**Subject: MHI's Response to US-APWR DCD RAI No. 119-792 Revision 0**

Response to Request for Additional Information  
No. 119-792 Revision 0

**US-APWR Design Certification  
Mitsubishi Heavy Industries  
Docket No. 52-021**

**RAI NO.:** 119-792  
**SRP SECTION:** 06.02.01.05- MINIMUM CONTAINMENT PRESSURE ANALYSIS FOR EMERGENCY CORE COOLING SYSTEM PERFORMANCE CAPABILITY STUDIES  
**APPLICATION SECTION:** SRP 6.2.1.5  
**DATE OF RAI ISSUE:** 12/3/2008

Figure-1 Containment Pressure

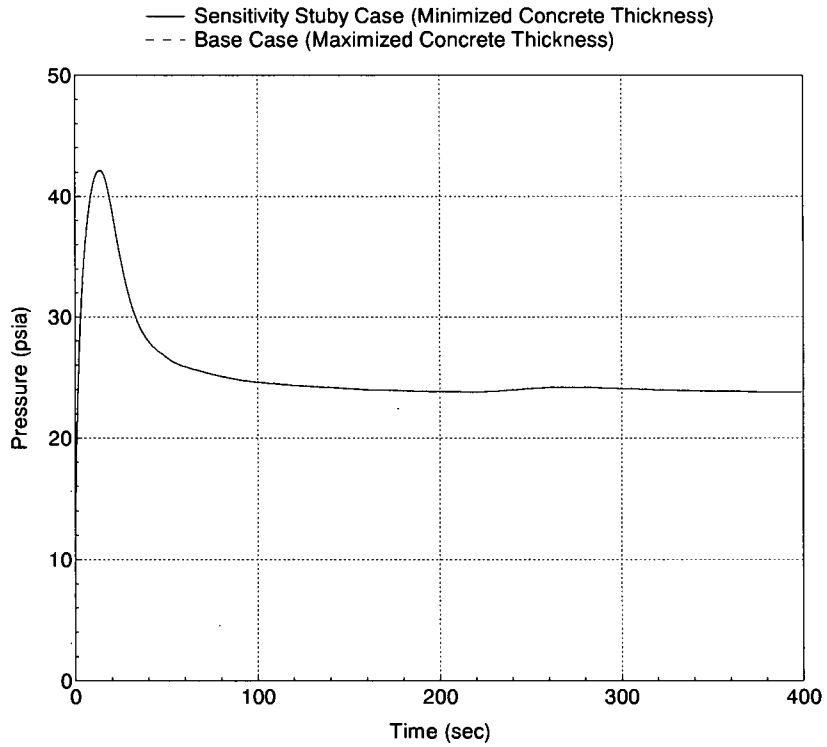
6.2.1.5: Comparing Table 6.2.1-30 with Table 6.2.1-9 (for nominal breaks), the heat transfer areas are always larger in Table 6.2.1-30 (to increase the heat transfer), however thickness of concrete and other materials appeared to be larger as well. It appears that for conservative calculations the thicknesses of the walls in contact with the exterior cold temperature should be minimized rather than maximized. Please, discuss and/or justify the used thicknesses.

In order to confirm that the treatment of the wall thickness of conductors in contact with the exterior atmosphere was appropriate for the minimum pressure analysis, a sensitivity study was conducted. In the sensitivity study, the wall thickness of the concrete in the containment cylinder was changed from 53.9 inch (the value used for the minimum containment pressure analysis) to 52.0 inch (the value used for the maximum containment pressure analysis). The results for the containment pressure and the containment atmospheric temperature are shown in Figure-1 and Figure-2, respectively. The results indicate that the change in the concrete shell thickness has virtually no effect on the containment pressure and temperature in this analysis. For the short duration of the transient, the heat from the containment penetrates only a short distance into the thick wall so that the change in thickness beyond the penetration depth has no effect.
